CCB 7549
Pre and Post Change Summary
PCN #: MFOL-15LRFR707

Pre and Post Change Summary – Lead frame Design

PRE CHANGE

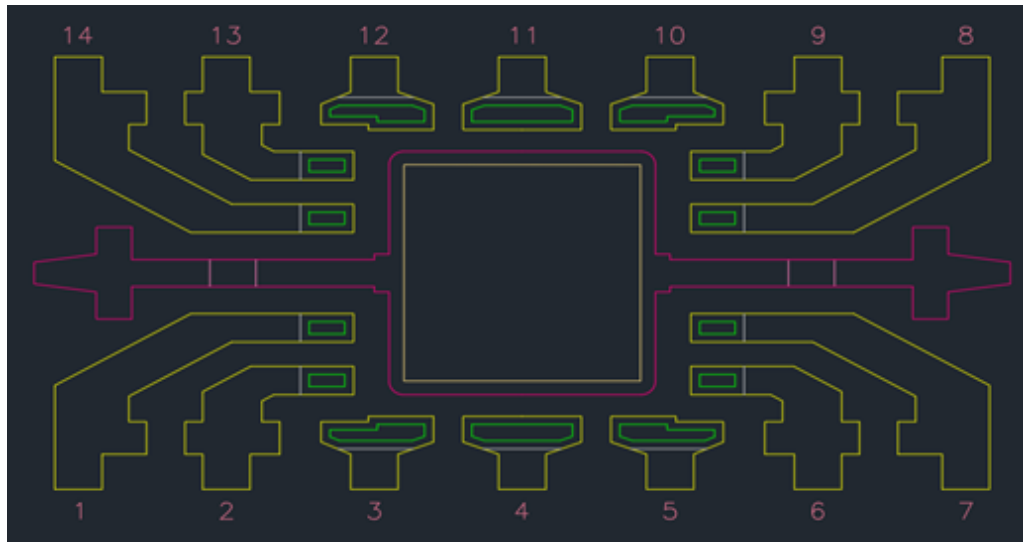
Leadframe Material	CDA194
Leadframe Paddle Size	90 X 90 mils
Leadframe DAP Surface Prep	Ag

POST CHANGE

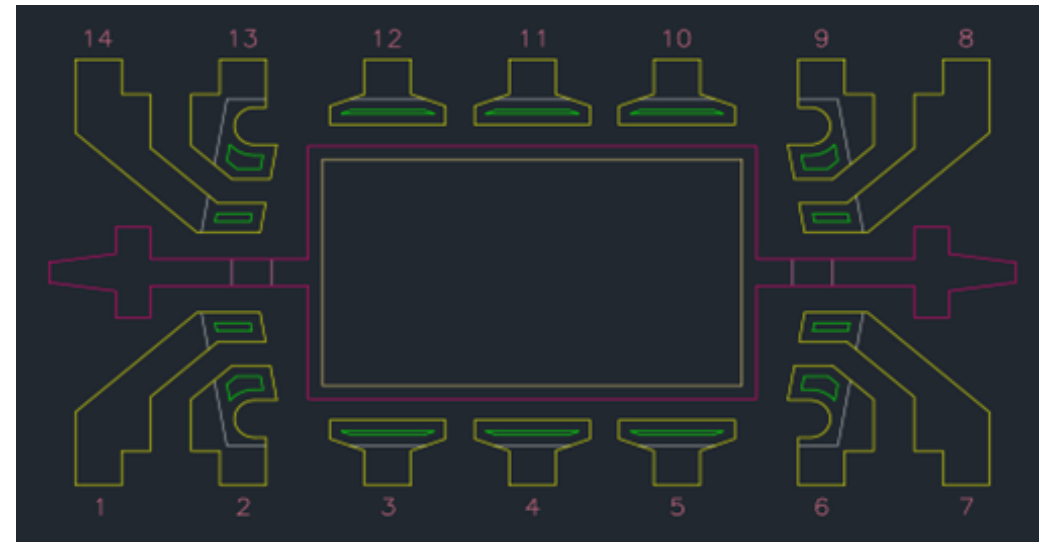
Leadframe Material	CDA194
Leadframe Paddle Size	95 X 155 mils
Leadframe DAP Surface Prep	Bare Cu
